## Product Change Notice

Change Vf range of ASMT-QGBE-NGJOE

ASMT-QGBE-NGJOE

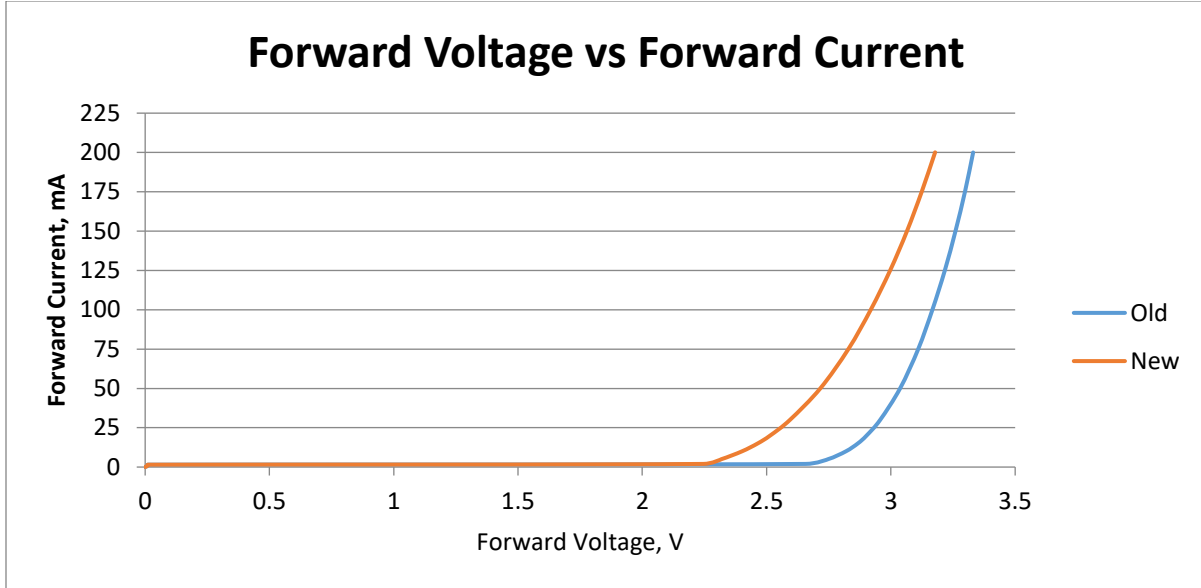
Vf Range	Before		After	
	Min	Max	Min	Max
	3.2	4.1V	2.9V	3.8V

There will be no change on fit, form, quality and reliability of final product. Vf characteristic is slightly difference as illustrated below:

Bin	Min.	Max
S4	2.90	3.20
S5	3.20	3.50
S6	3.50	3.80
